FORD:

2015-2016 F-250, F-350, F-450

This article supersedes TSB **15-0106** to update the Issue Statement, Service Procedure and Part List.

TSB 16-0041 (Continued)

Figure 1 - Article 16-0041

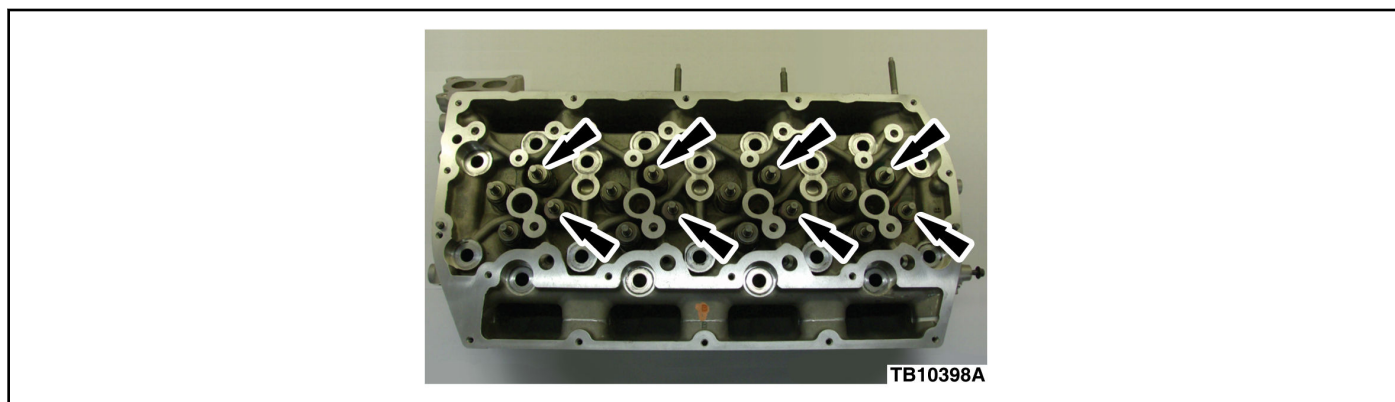
Some 2015-2016 F-Super Duty 250-450 Pickup vehicles equipped with a 6.7L diesel engine and built on or before 2/23/2016 may exhibit a runs rough/misfire condition only during the exhaust regeneration process. This condition typically occurs on light throttle tip in between 64-113 Km/h (40-70 MPH) and will not set diagnostic trouble codes (DTCs). The concern may be intermittent and a knocking noise may be present during the concern.

1. Reprogram the powertrain control module (PCM) to the latest calibration using Integrated Diagnostic System (IDS) release 99.03 or higher. Make sure you are connected to the internet when entering module programming to obtain the latest updates. Calibration files may also be obtained at www.motorcraftservice.com
2. Did the customer indicate the message center displayed a Cleaning Exhaust Filter message prior to the concern?
 - a. Yes - proceed to Step 3.
 - b. No - proceed to Step 6.
3. Remove the left cylinder head. Refer to Workshop Manual (WSM), Section 303-01.
4. Replace all eight (8) exhaust valves and valve seals. Refer to WSM, Section 303-01. (Figure 1)
